TEXAS DEPARTMENT OF TRANSPORTATION

CONSTRUCTION CONTRACT CHANGE ORDER NUMBER: 01

CCSJ:	<u>3510-04-055</u>
Project:	<u>CC 3510-4-55</u>
Highway:	<u>SH 99</u>
County:	<u>FORT BEND</u>
District:	<u>12</u>
Contract Number:	<u>351004055</u>

DESCRIPTION: ADDED CONSTRUCTION PERIMETER FENCE
REASON: 3F - 3F-ADDITIONAL WORK DESIRED BY TXDOT
SECONDARY REASON(S):

Temporary Fencing Area

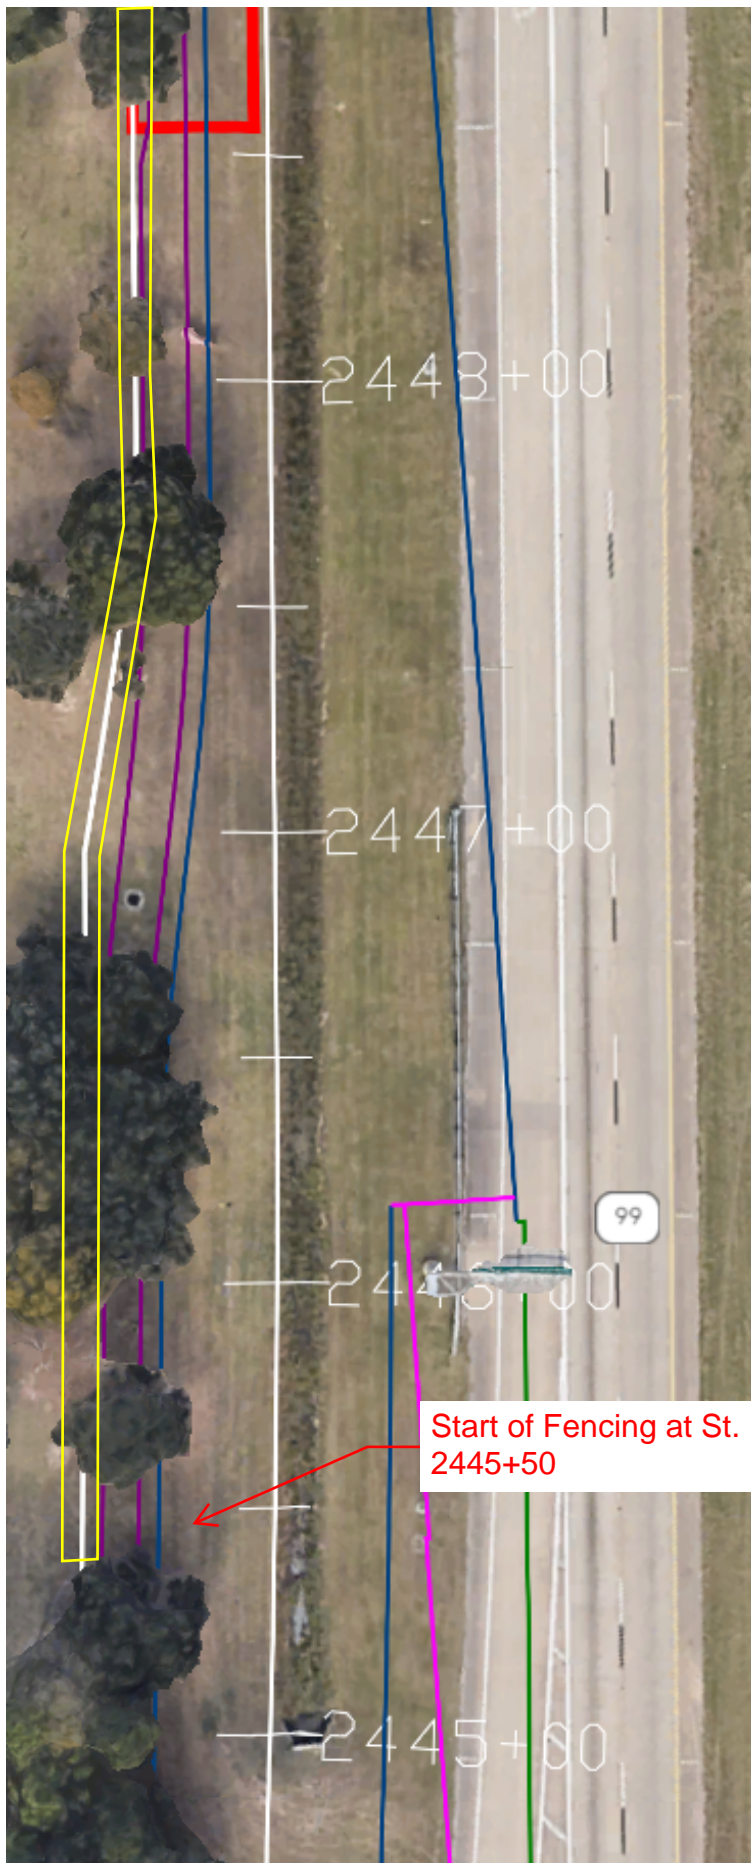
For facilitating the safety of the pedestrians during the construction process, TSC would like to install temporary fencing along the ROW from Station 2445+50 to 2469. This will help in providing a physical barrier as well as security for the site. The picture marking the length of fencing has been attached for your reference. Please review and let us know its viability.

RESPONSE: TxDOT has reviewed and accepts the request.			
By: Grant Hamman		Signature:	
		Date: 7/20/2023	
After reviewing the response; we anticipate:			
That a change order will be required?		<input type="checkbox"/> Yes	<input checked="" type="checkbox"/> No
That there will be an increase in the cost of the project?		<input type="checkbox"/> Yes	<input checked="" type="checkbox"/> No
That there will be an increase in the time of the project?		<input type="checkbox"/> Yes	<input checked="" type="checkbox"/> No
